寄件者: Chong Hermose [REDACTED]
寄件日期: 2026 年 10 月 8 日 14:57
收件者: tpbpd/PLAND <tpbpd@pland.gov.hk>
副本: Jason Sek Hei WONG/PLAND <jshwong@pland.gov.hk>; Athena Pui Yin LAI/PLAND <apylai@pland.gov.hk>
主旨: S.16 Planning Application No. A/YL-SK/468 - 回應部門意見

Response to Comment From: Drainage Services Department (Mr. Jeff Tse) Received Date: 23 September 2026	
I.	According to our record, the size of the existing DSD's u-channel (SUP1028353) should be 300mm instead of 600mm. The applicant should check and ensure the hydraulic capacity of the existing drainage facilities would not be adversely affected by the captioned development.	According to the government open data on GEOINFO MAP and our site measurement shown in Appendix C, the SUP1028353 is 600mm. The hydraulic capacity of the existing drainage facilities is included in Appendix F. Please refer to below link: https://www.map.gov.hk/gm/s/dsd/SUP1028353
II.	According to Drawing No. 20250711b, it is noted that levelling works will be carried out under this application. Please be reminded that peripheral surface channels shall be provided along the site boundary at the existing/original ground level (instead of the revised ground level) t

Appendix D
Proposed Drainage Arrangement

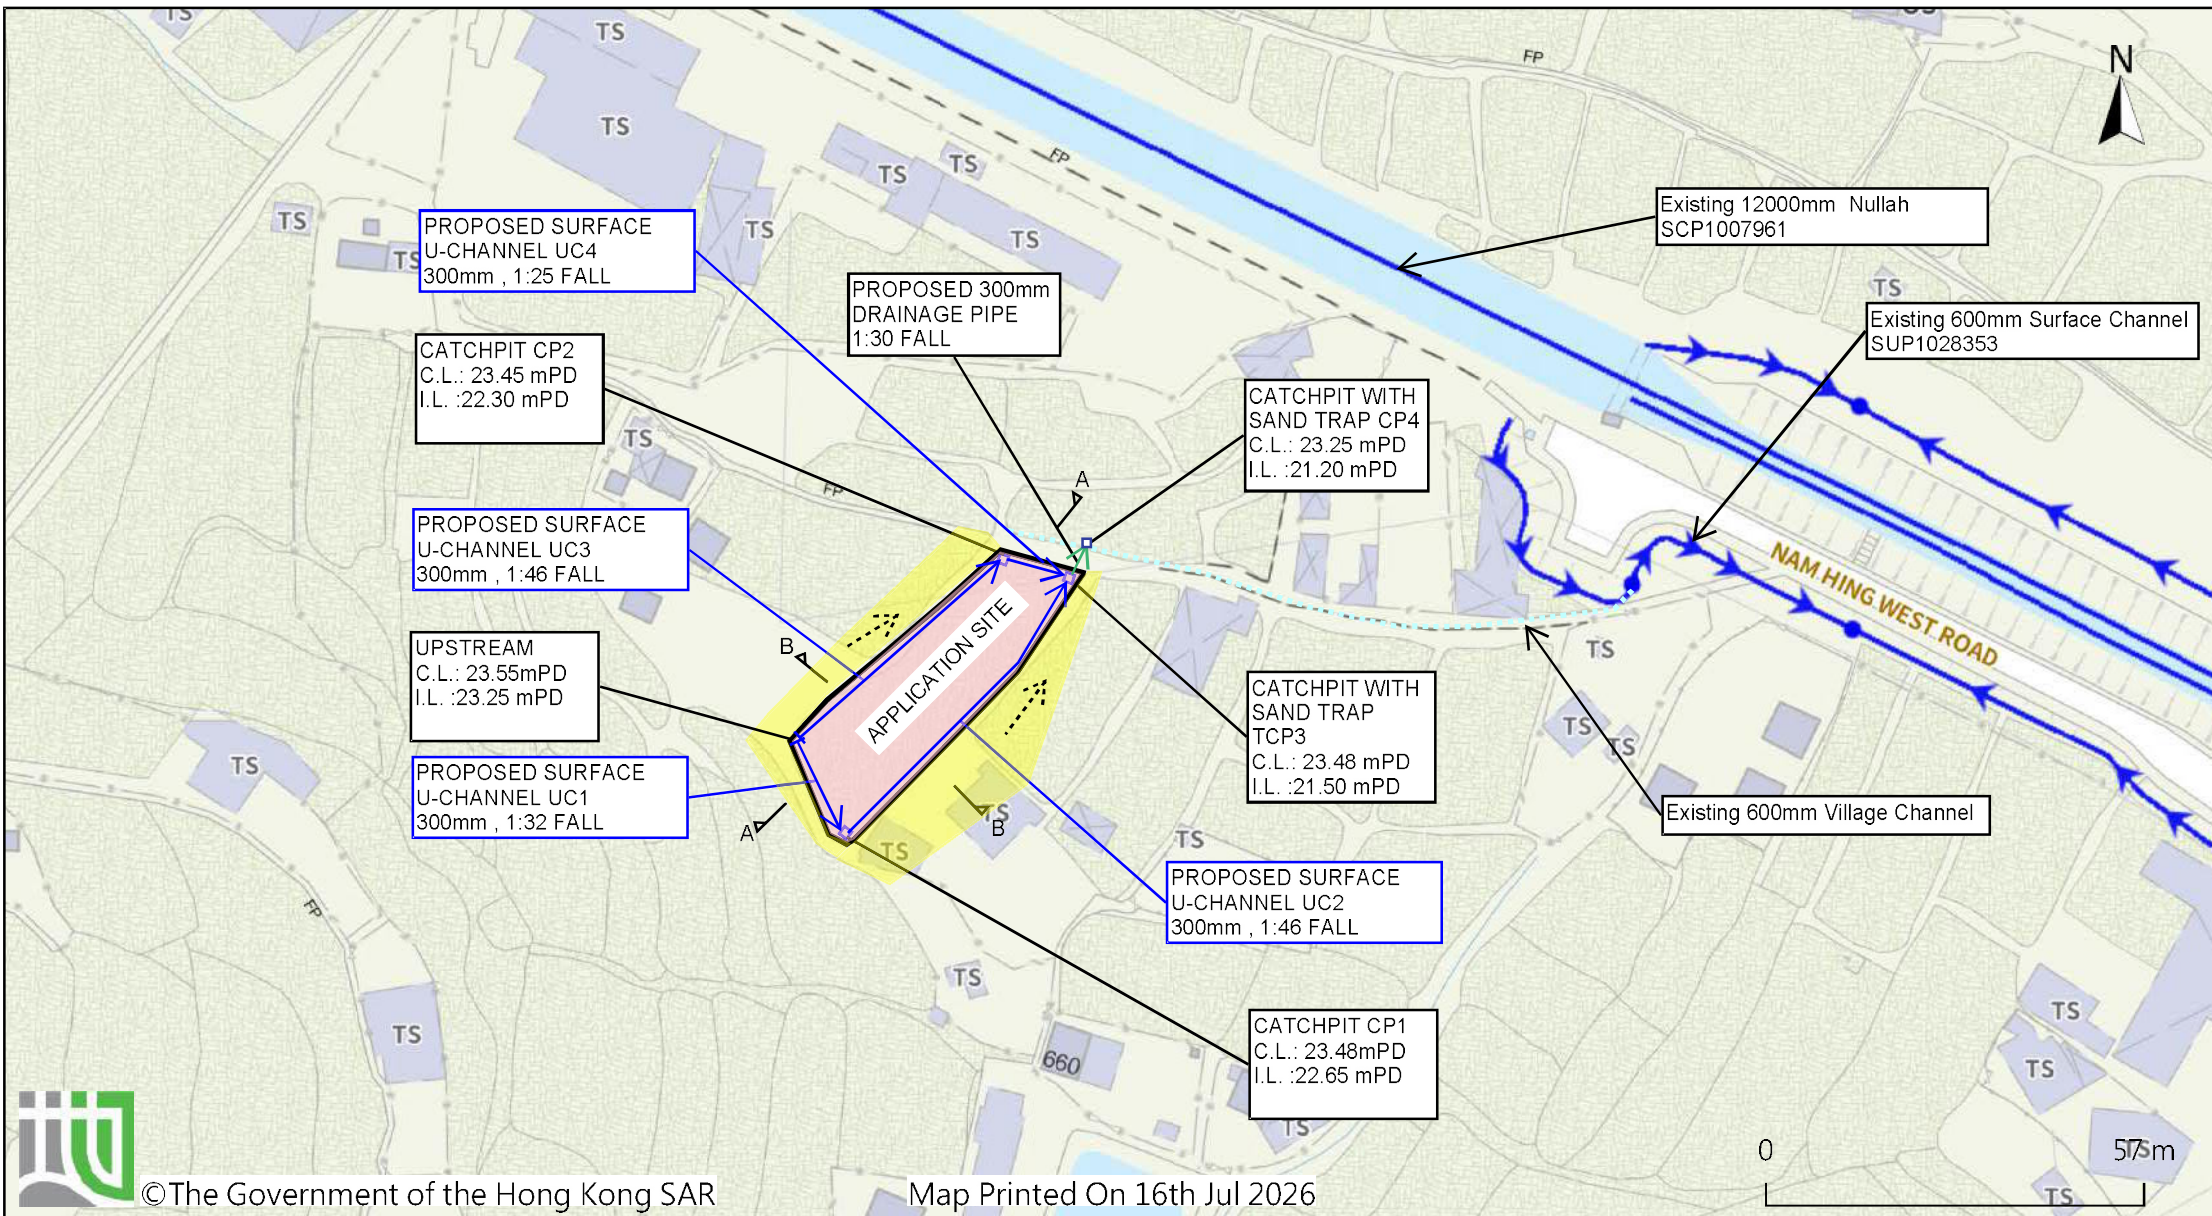
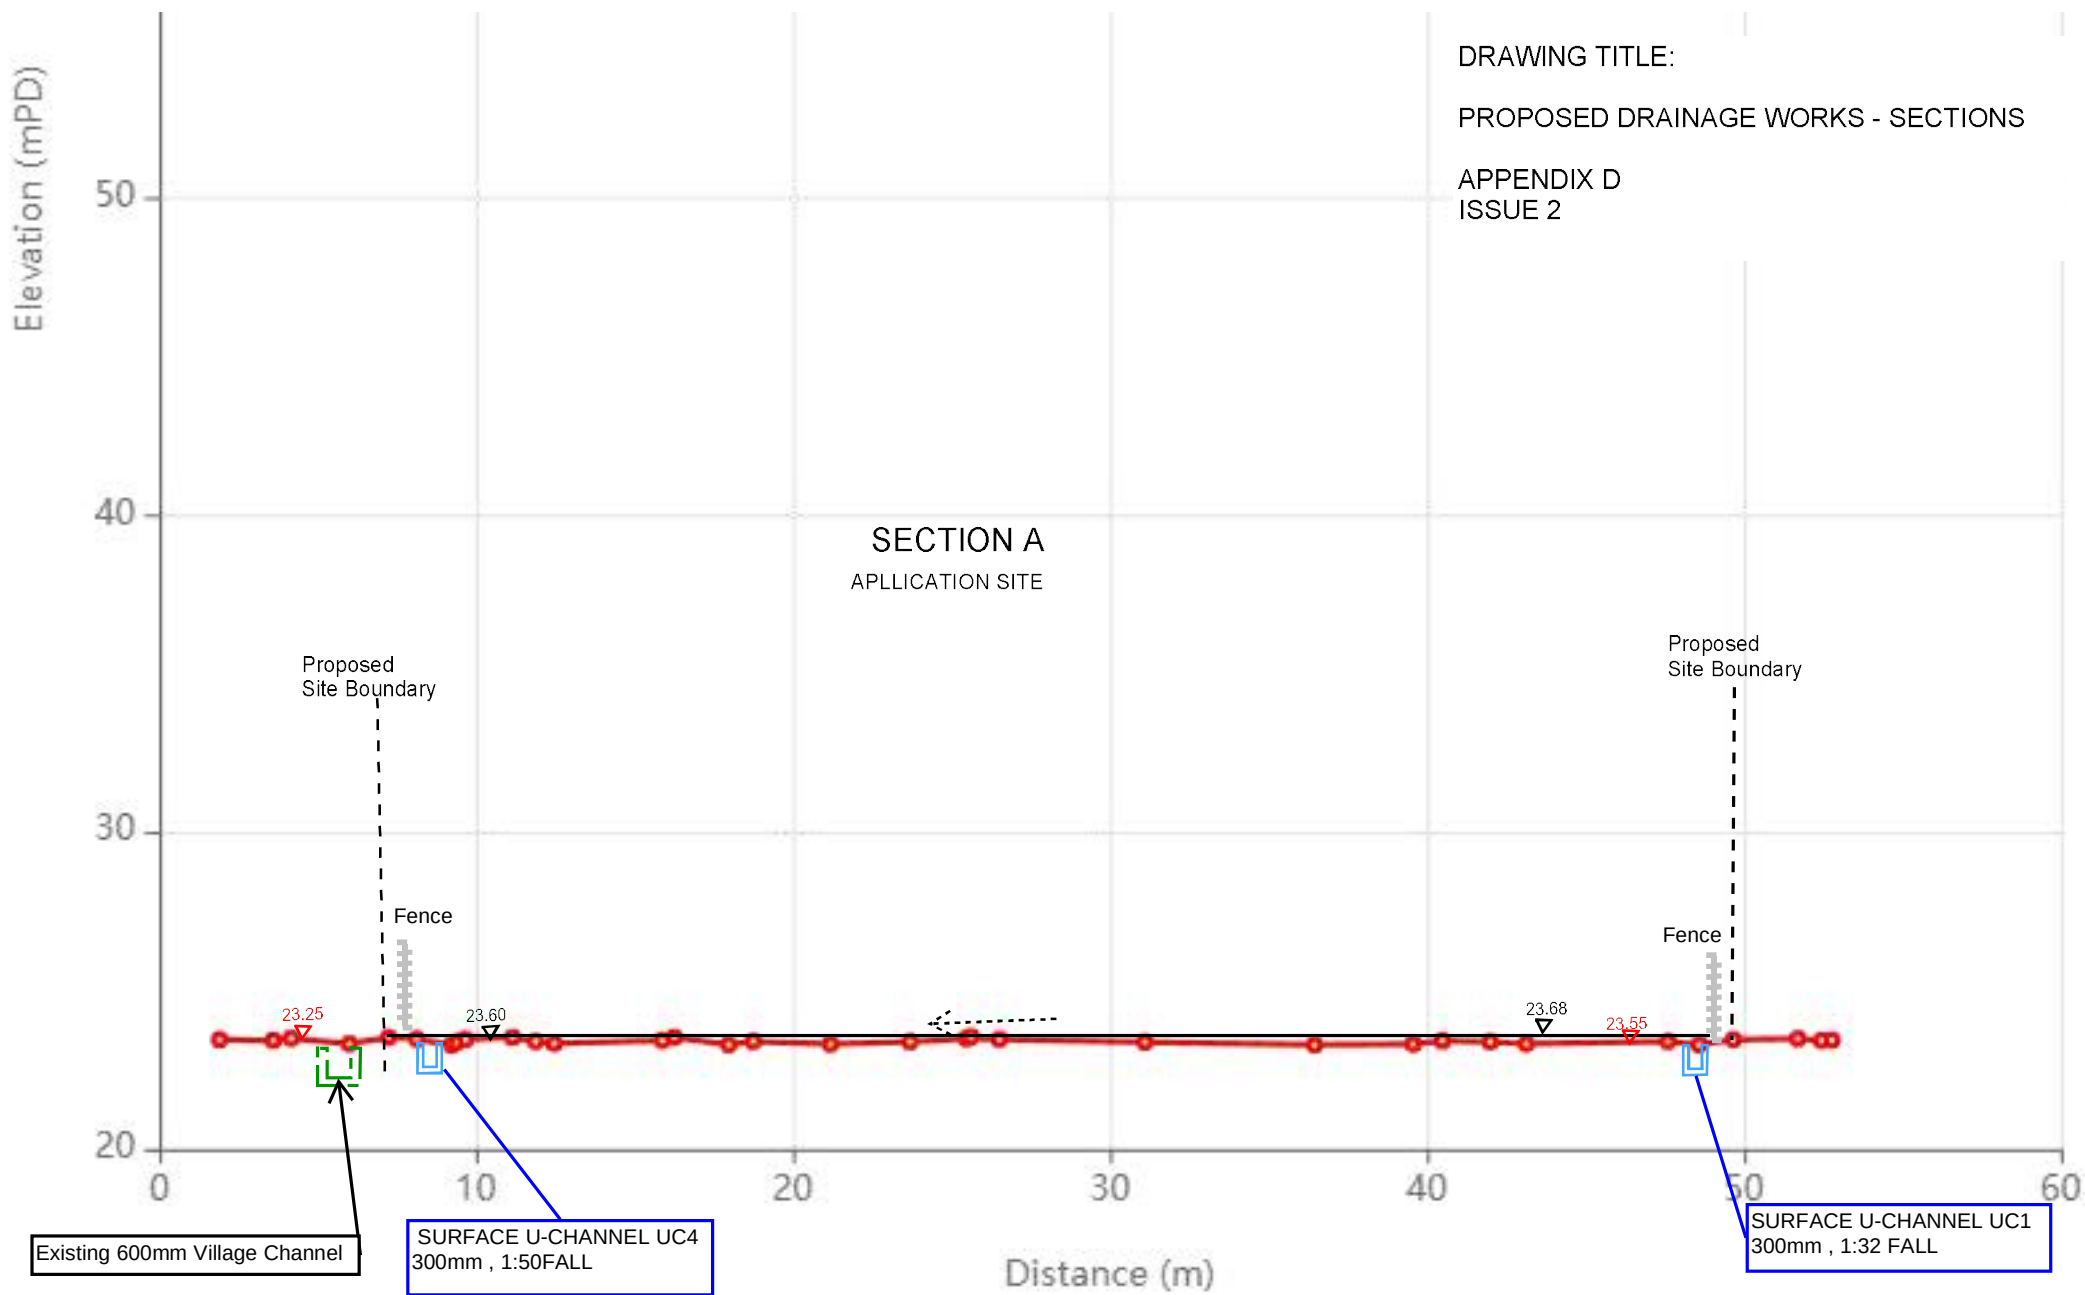
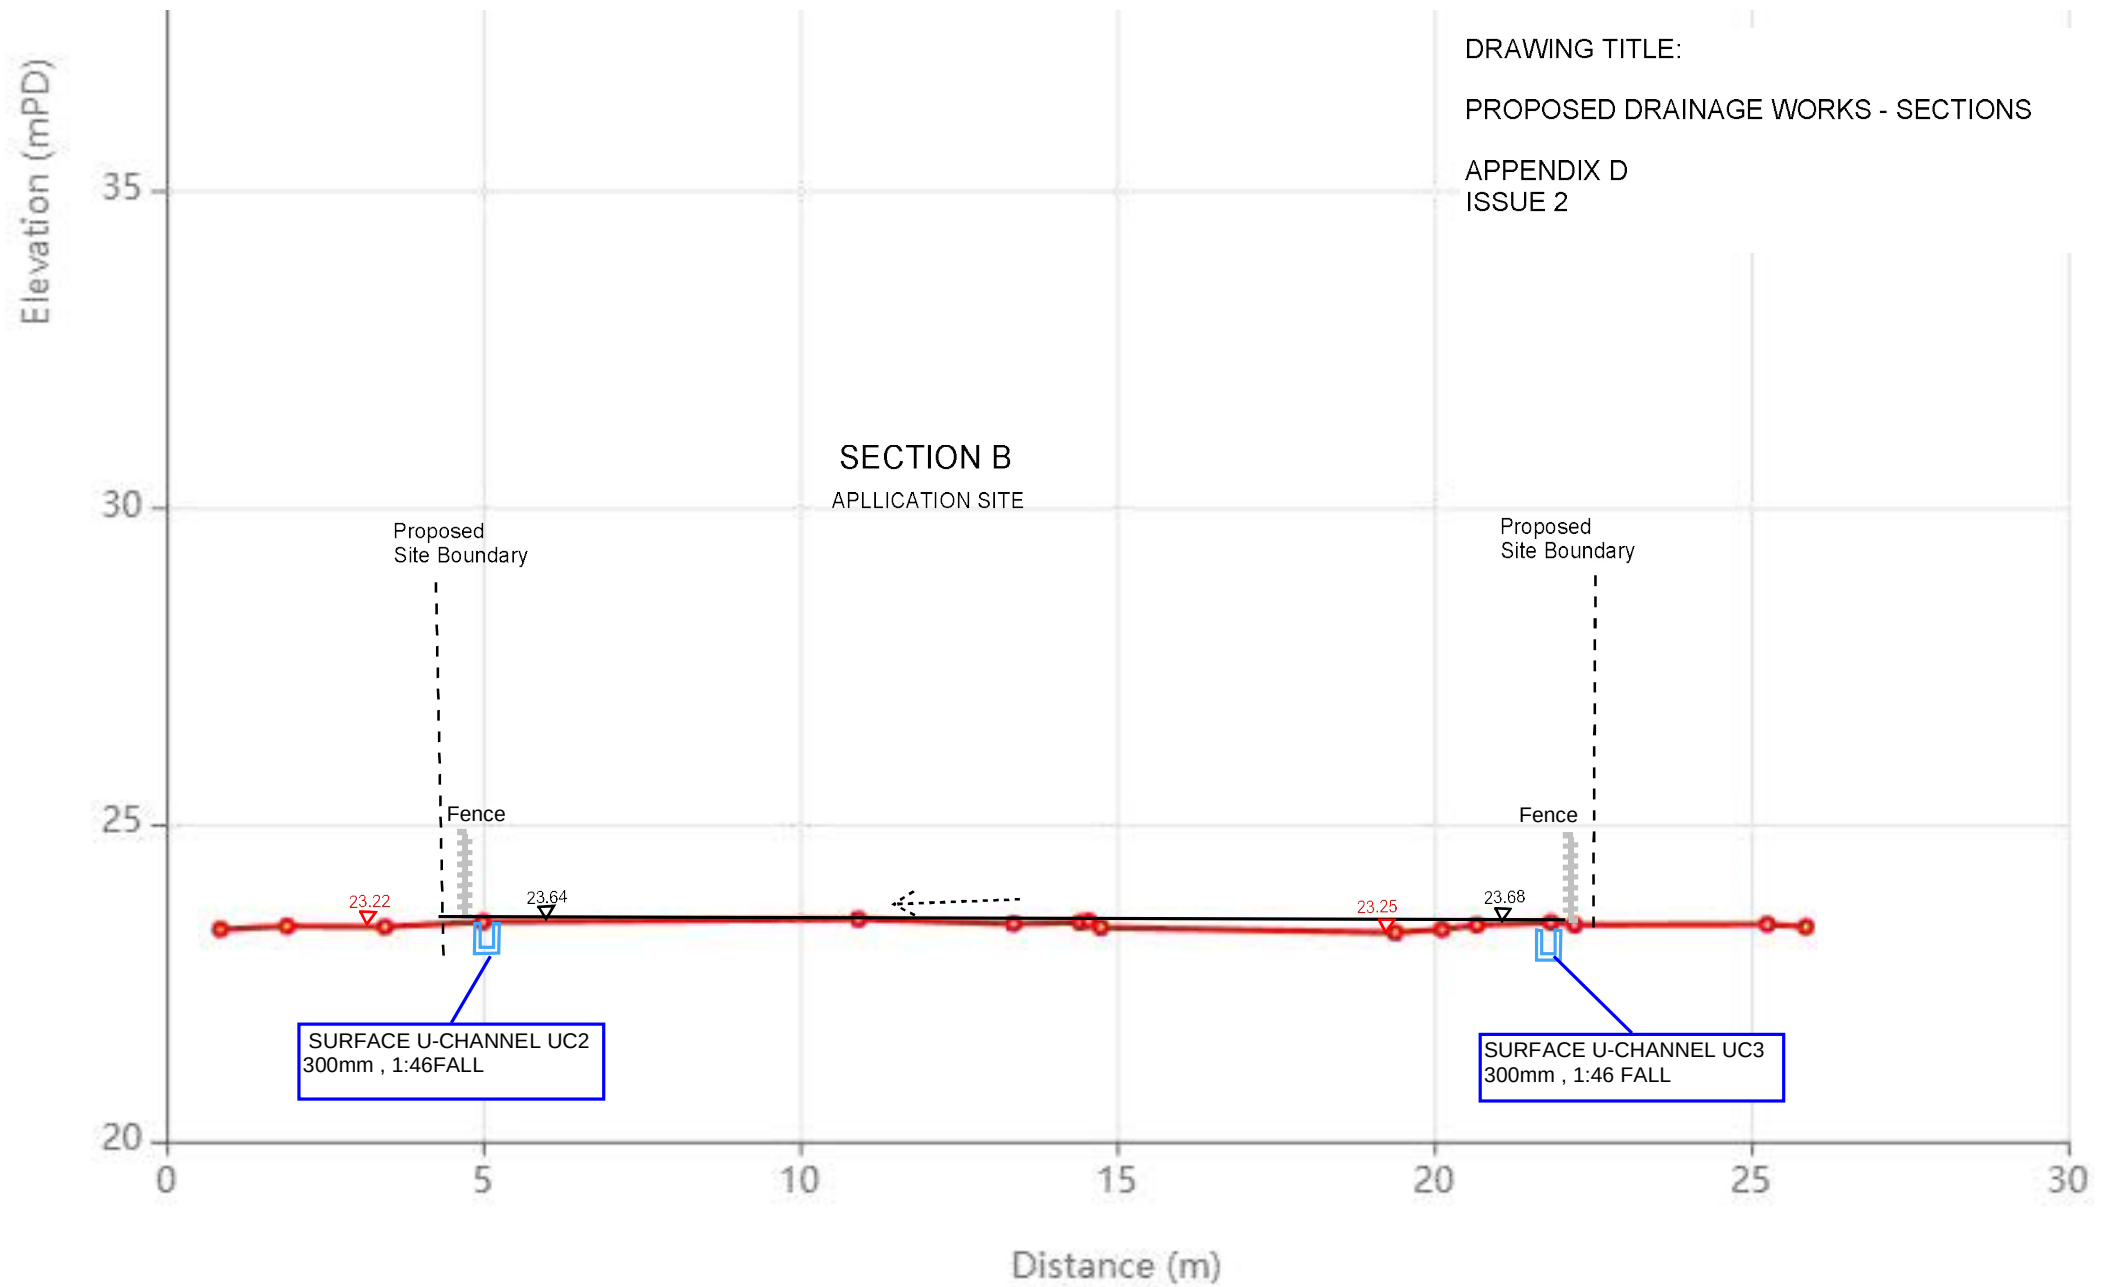
III.	Referring to cross sections provided, openings will be provided at the toe of the proposed hoarding along the site boundary. Please provide the details of the proposed openings (i.e. the elevation of the proposed hoarding with opening, etc.) and demonstrate that such openings are sufficient and adequate to intercept the existing overland flow passing through the site.	After reconsideration, no hoarding will be erected.
IV.	Please indicate the invert level at the proposed start points of peripheral surface channels on the drainage plan in Appendix D for reference.	Noted and Appendix D is updated.

V.	Catchpit(s)/manhole(s) should be provided at the proposed intersections of the existing 600mm u-channels. Please also provide the connection details with relevant levels (i.e. C.L., I.L., B.L., G.L., etc.) to the existing 600mm u-channel for review.	Noted and Appendix D is updated.
VI.	Sand trap or provision alike should be provided at the proposed catchpit (TCP3) before the collected runoff is discharged to the public drainage facilities.	Noted, sand trap will be provided.
VII.	The existing 600mm u-channel, to which the applicant proposed to discharge the stormwater from the subject site was not maintained by this office. The applicant(s)	Noted and DLO/YL will be consulted.
